Latch Handle Disable

National Traffic and Motor Vehicle Safety Number (NHTSA): NHTSA recall number: 09V-318, Transport Canada number 09-240

APPLICATION
ORION NG

Figure 1-1 Transom Window

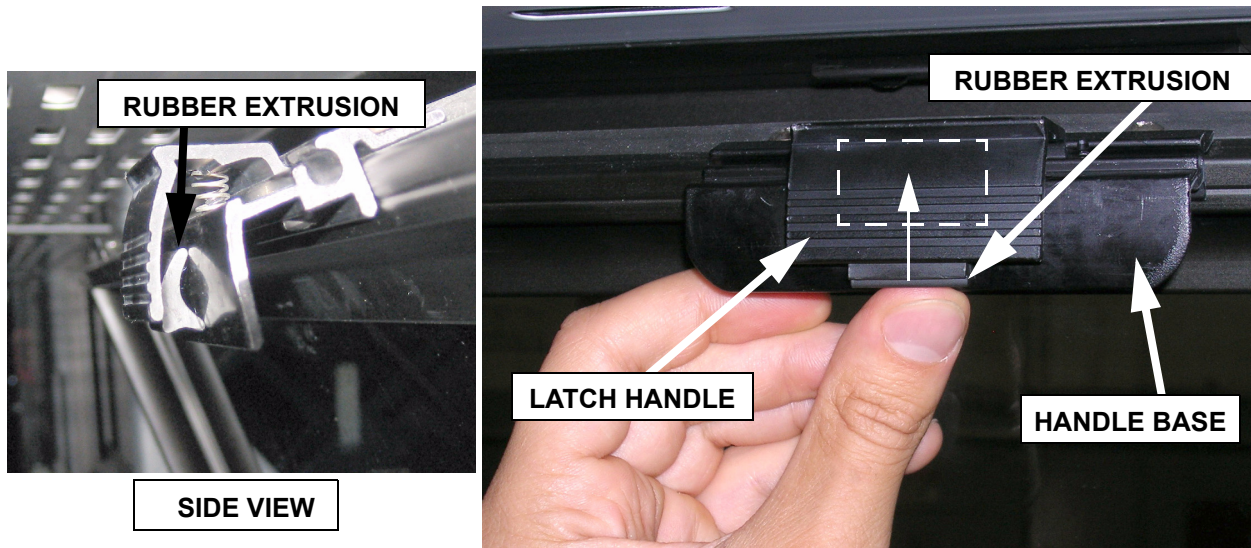
The passenger windows have a tip-in transom window which is attached by shocks and screws. These screws and shocks may loosen or fail and the window may dislodge and fall into the bus.

This procedure involves placement of a rubber extrusion into the latch handle to prevent the transom window from opening.

1. Open the transom window. See [Figure 1-1](#)
2. Place rubber extrusion between the latch handle and handle base. See [Figure 1-1](#)
3. Slide rubber extrusion upward. See [Figure 1-1](#)
